ADDENDUM # 1 Questions and Clarifications

Administration Building HVAC Renovation IFB #FED2019-02

**Greater Peoria Mass Transit District (GPMTD/CityLink)
Administration Building HVAC Renovation**

Addendum 01

Sheet M1.0 – BASEMENT MECHANICAL PLAN

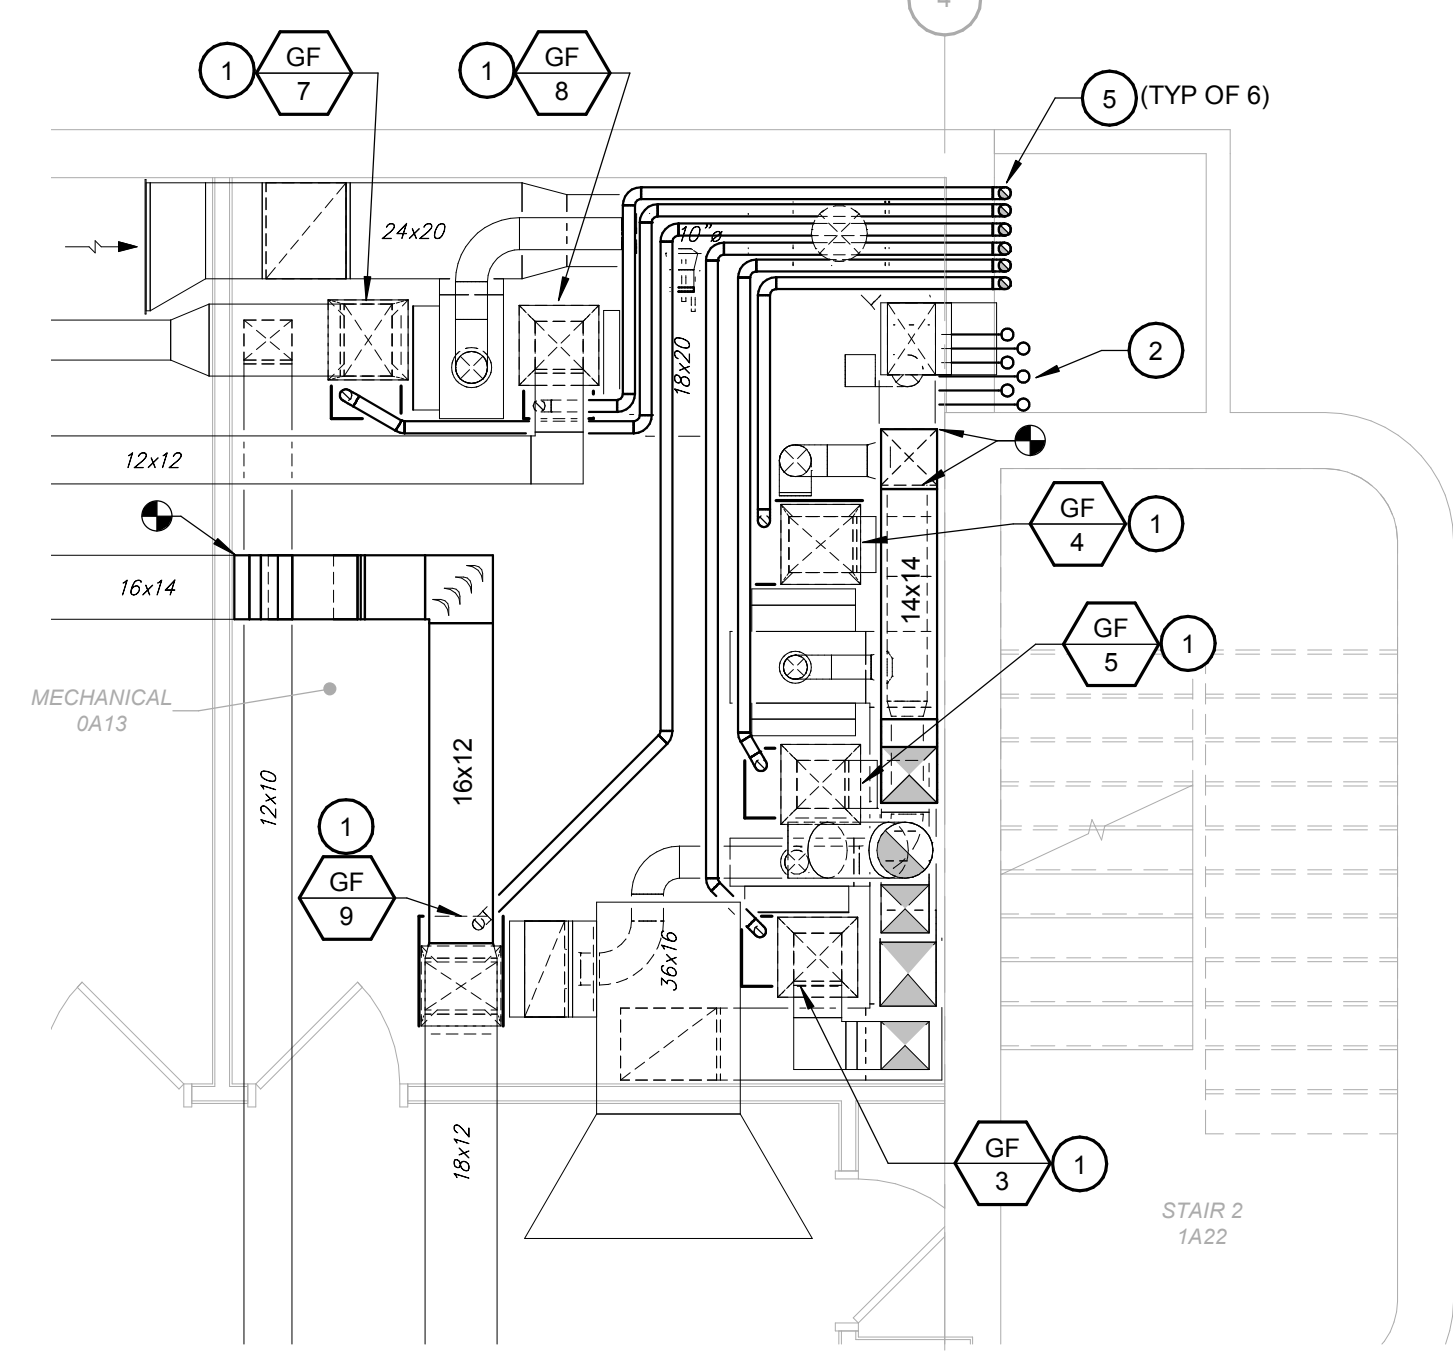
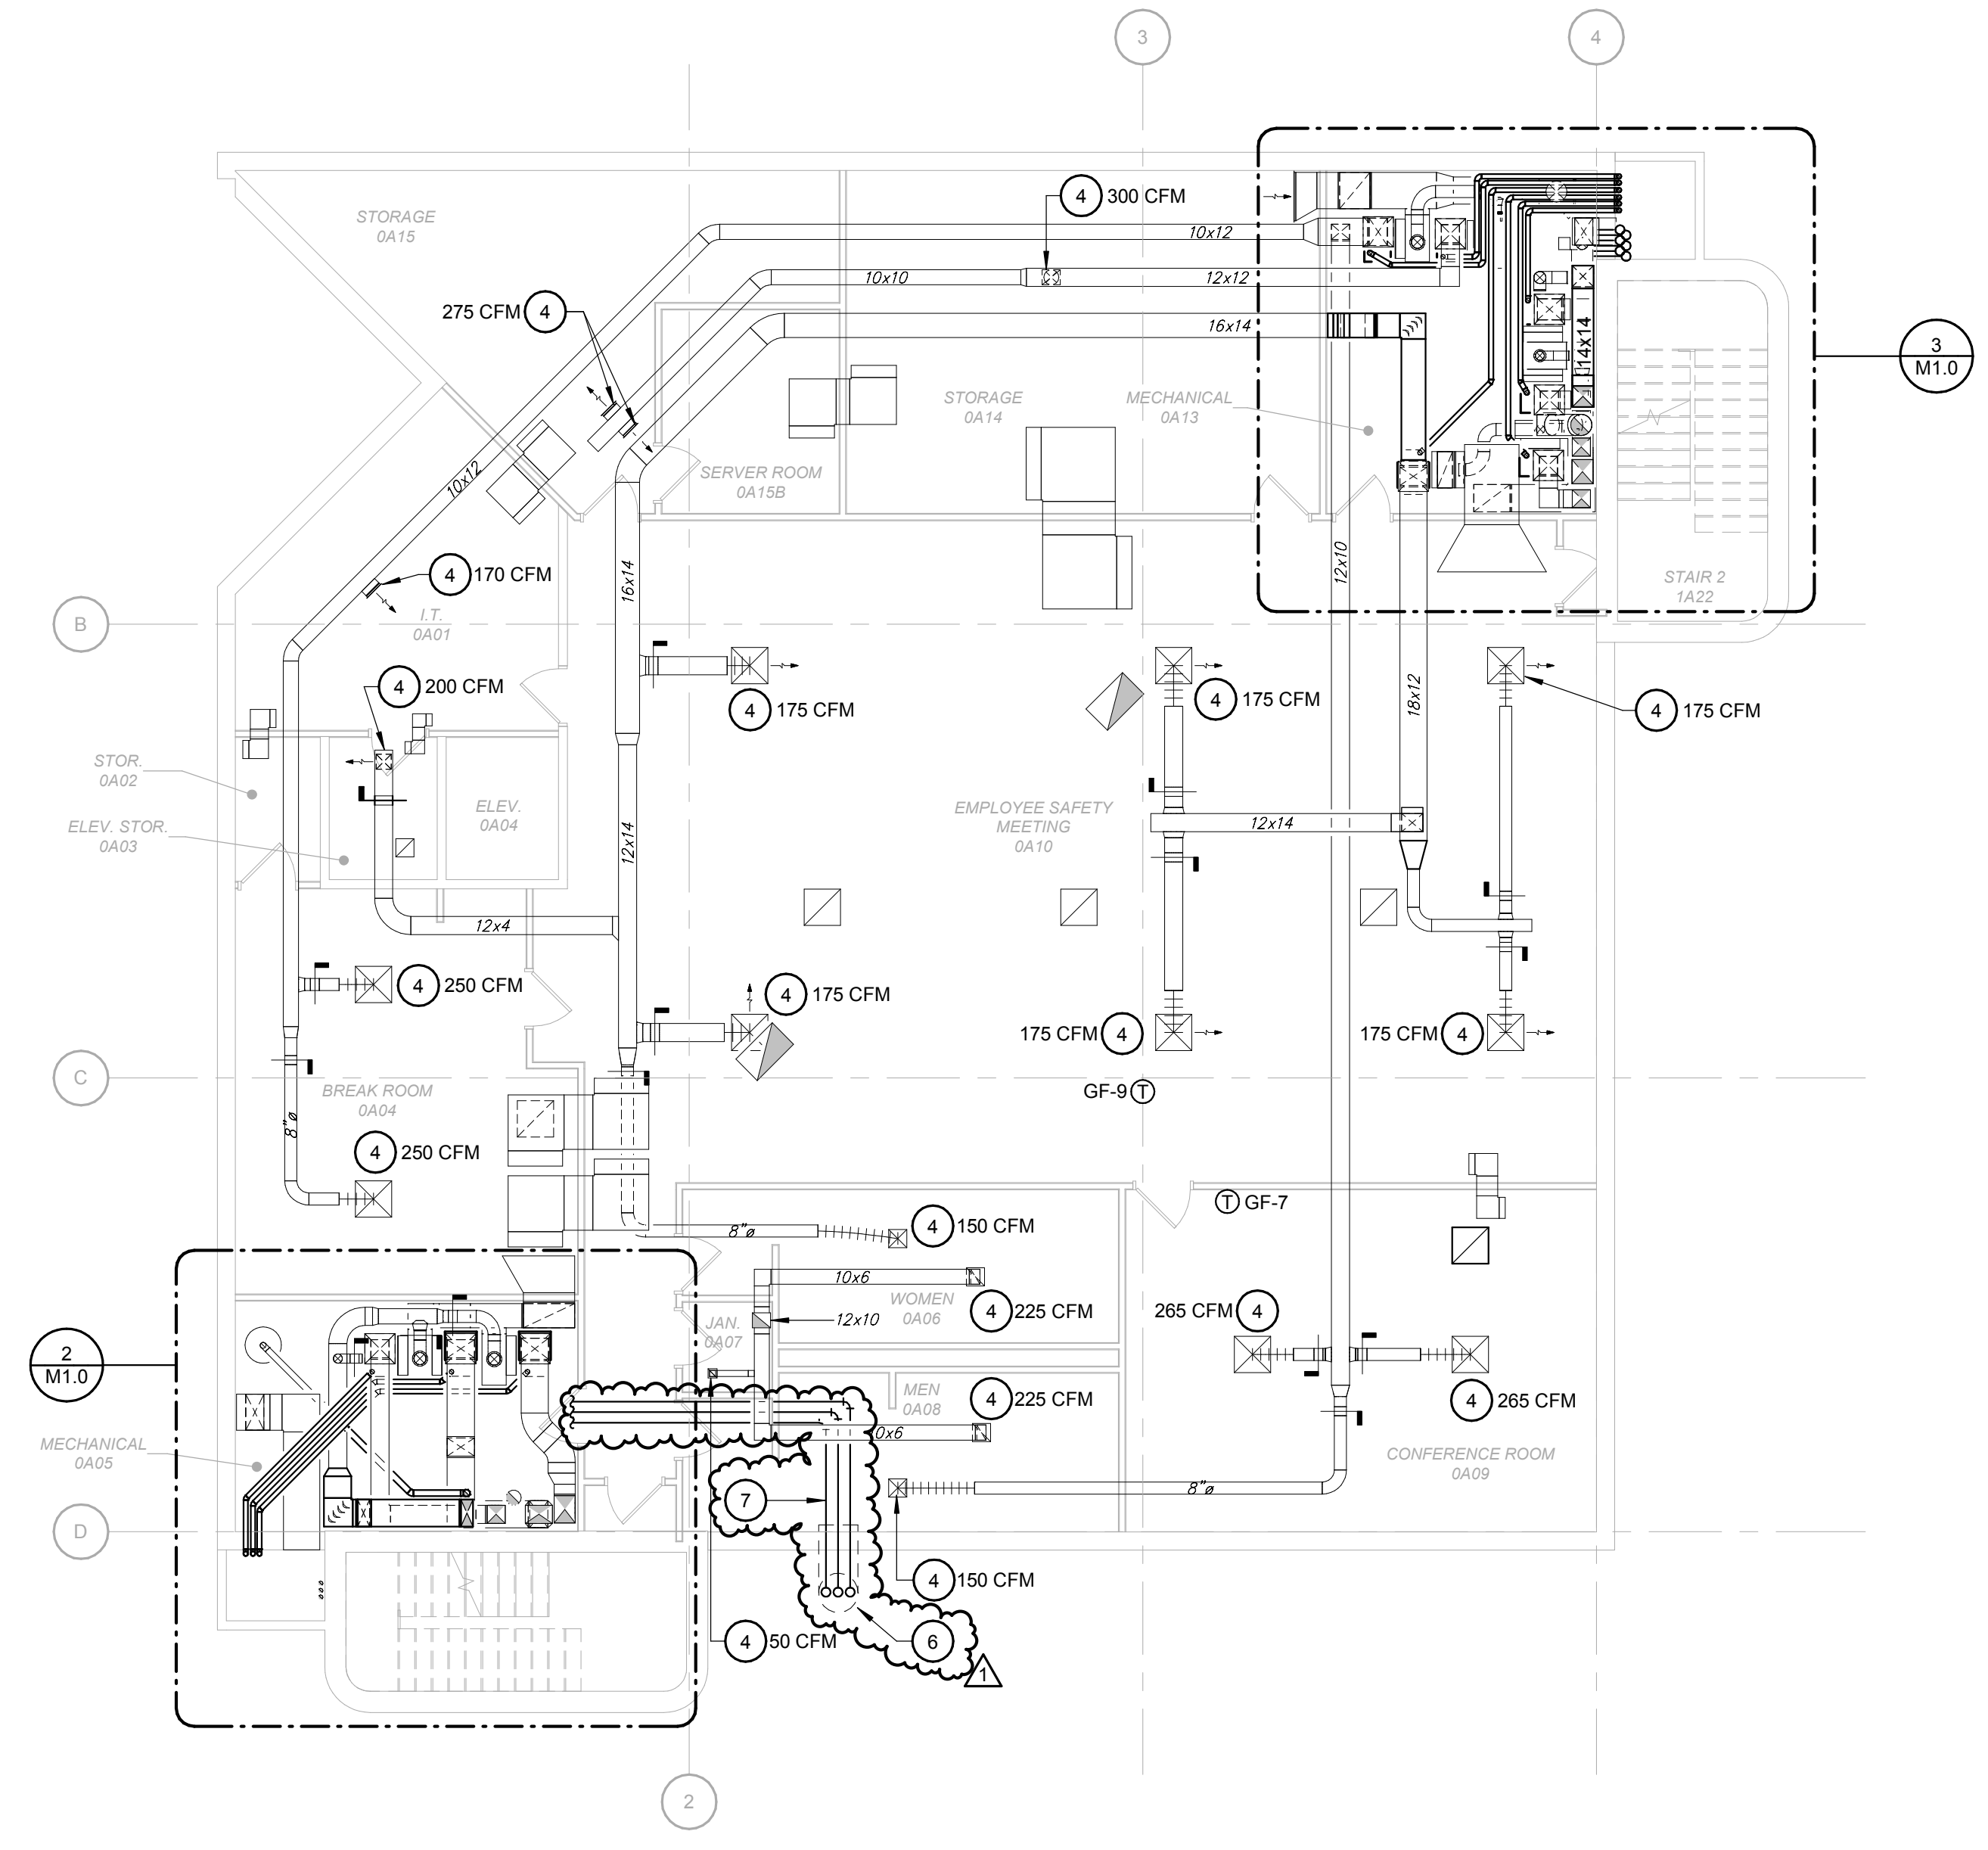
1. REVISION: Revise Basement Mechanical Demolition Plan per attached M1.0.
2. REVISION: Added Keynotes 6, 7, and 8.
3. REVISION: Modified extent of existing flue demolition.

- 6 PIPING TUNNEL FROM ABOVE CEILING TO GRADE ABOVE. TUNNEL TO REMAIN FOR RE-USE.
- 7 RLRS ABOVE RESTROOM CEILING. FOLLOW ROUTE OF EXISTING LINESETS. COORDINATE CEILING PATCHING AREAS.

- 8 NEW 5"Ø WATER HEATER FLUE UP TO ROOF. TERMINATE AT ROOF WITH ROOF CAP.

Sheet M1.1 – FIRST FLOOR MECHANICAL PLAN

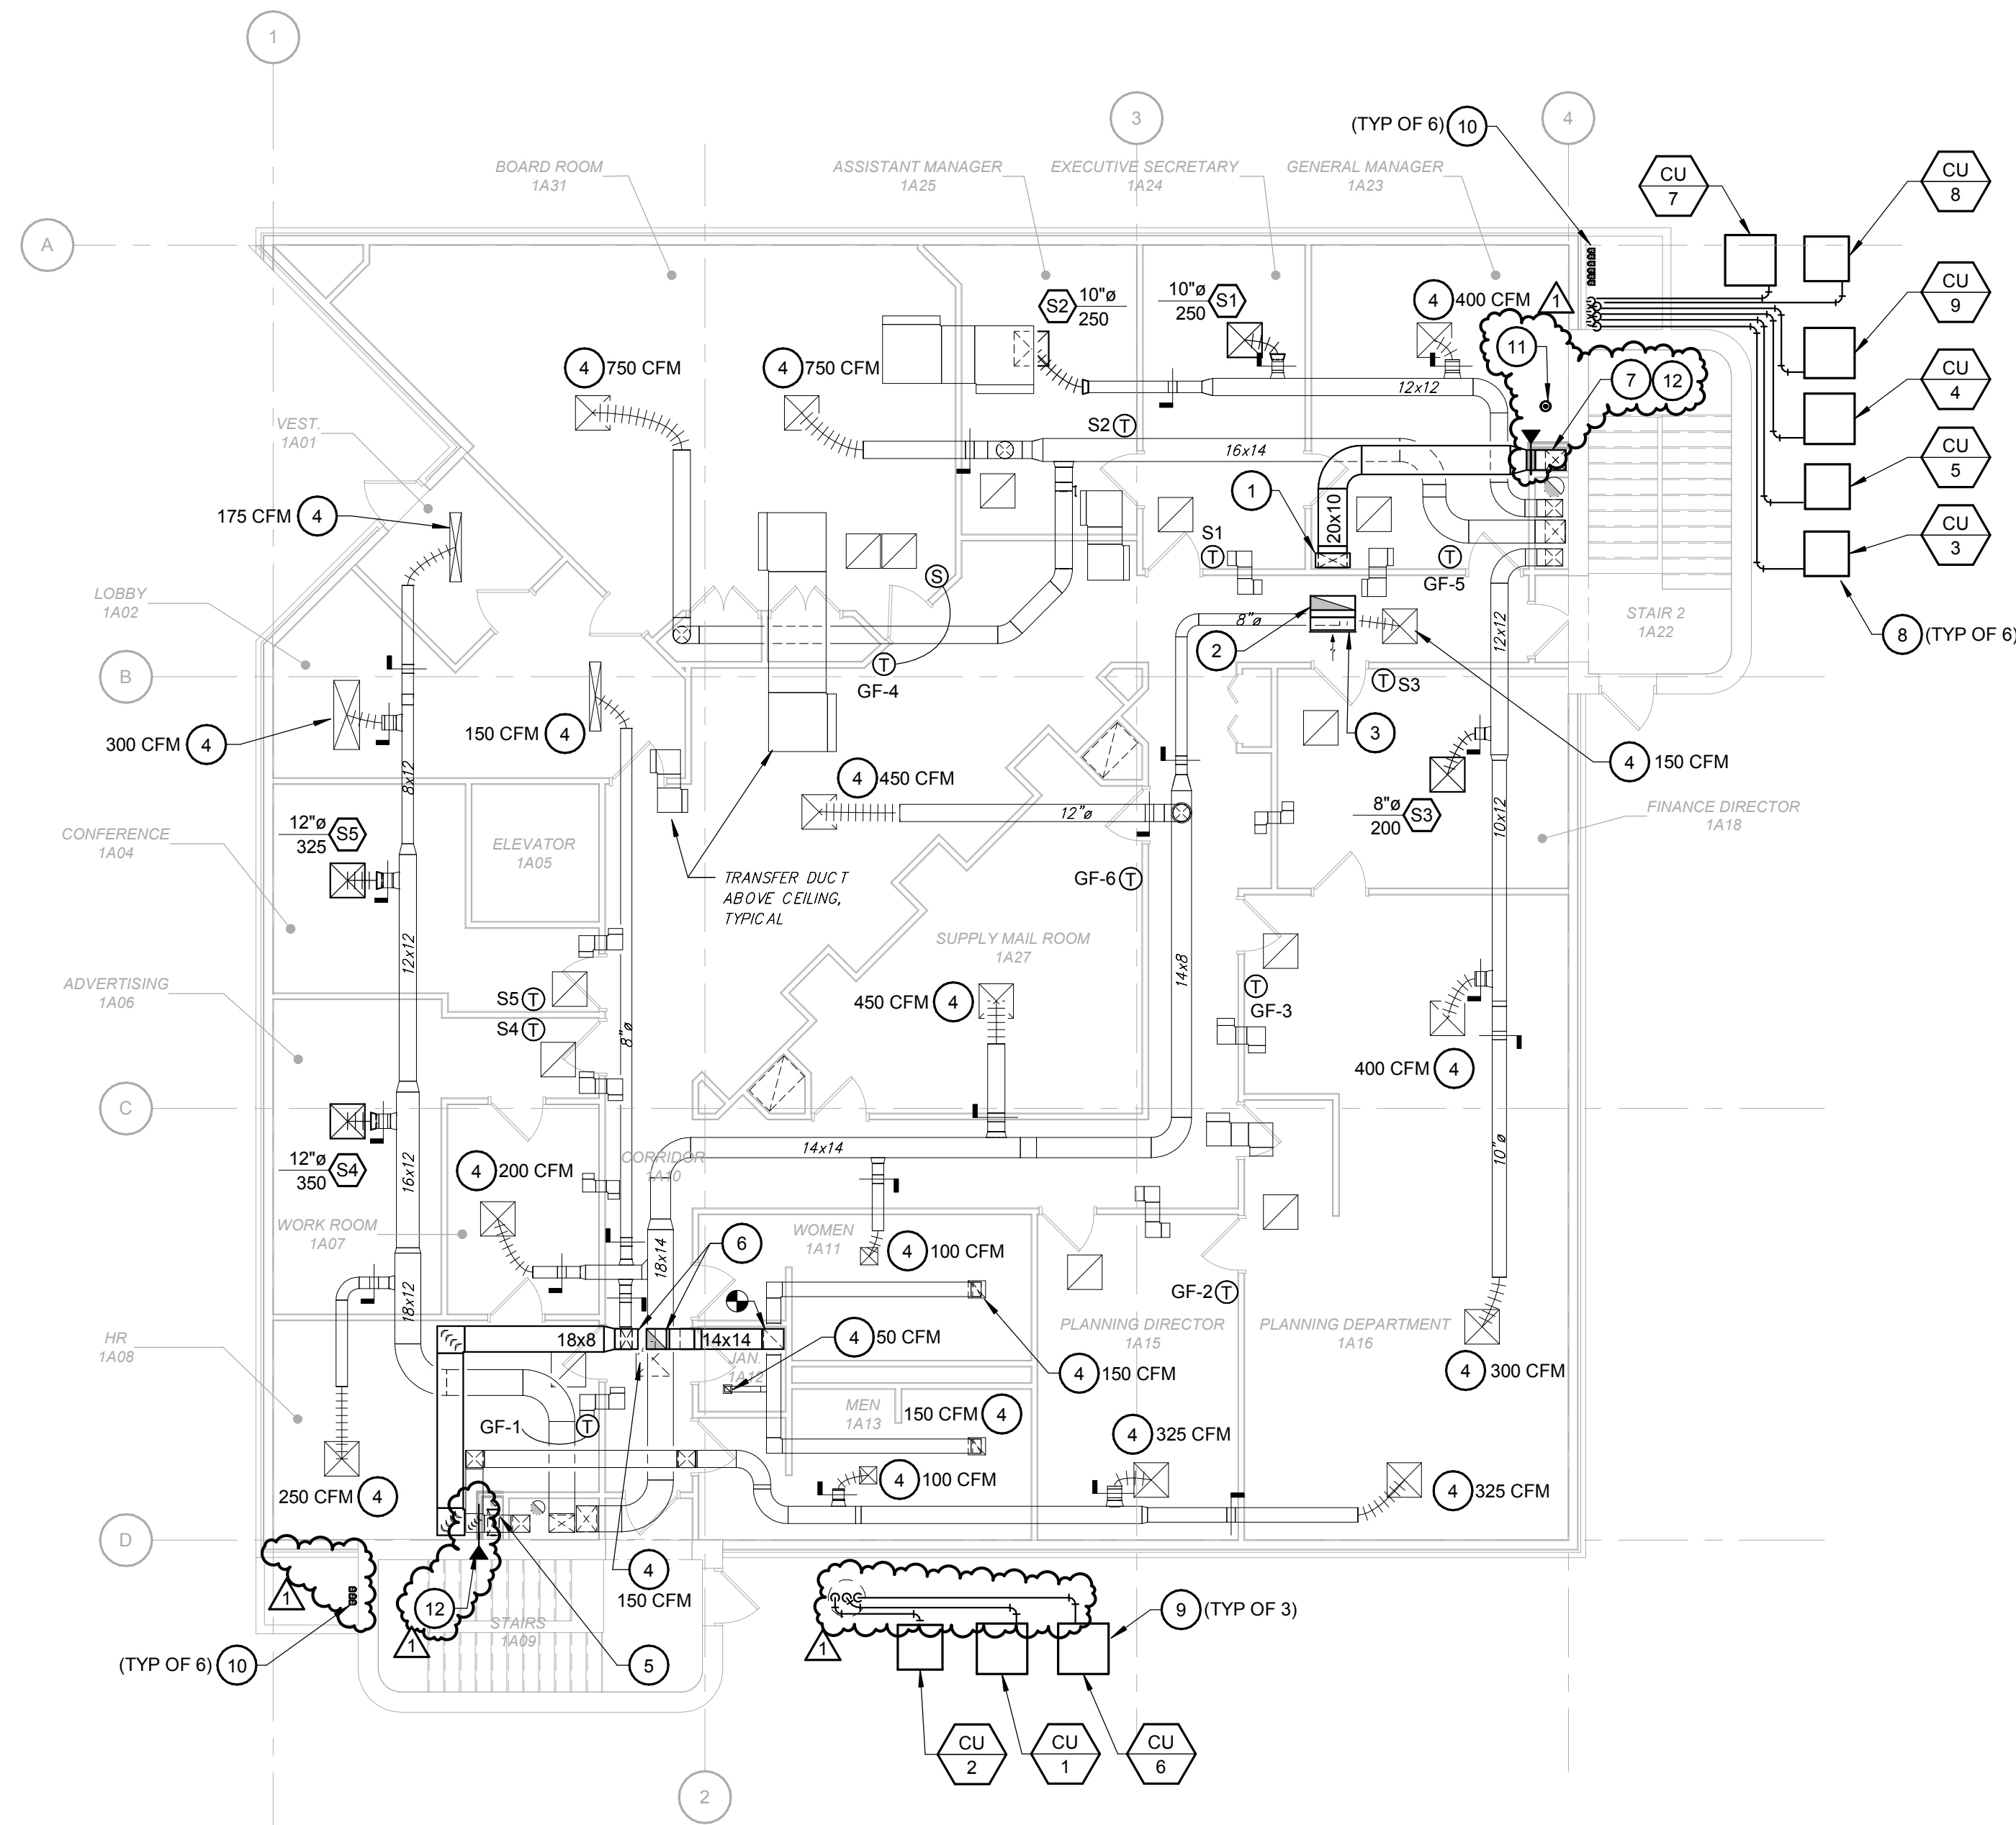
1. REVISION: Revise First Floor Mechanical Plan per attached M1.1.
2. REVISION: Revised Keynotes 9 and 10 and associated scope.
3. REVISION: Added Keynotes 11 and 12 and associated scope.

- 10 FURNACE FLUES FROM BELOW, TERMINATE MIN. 3'-0" ABOVE GRADE. PROVIDE MINIMUM 48"HX36"W STAINLESS STEEL PLATE ON EXTERIOR WALL BEHIND FLUES.
- 11 RELOCATED SPRINKLER HEAD, CENTER IN CEILING TILE.

- 12 FIRE DAMPER IN PENETRATION TO CHASE WALL.
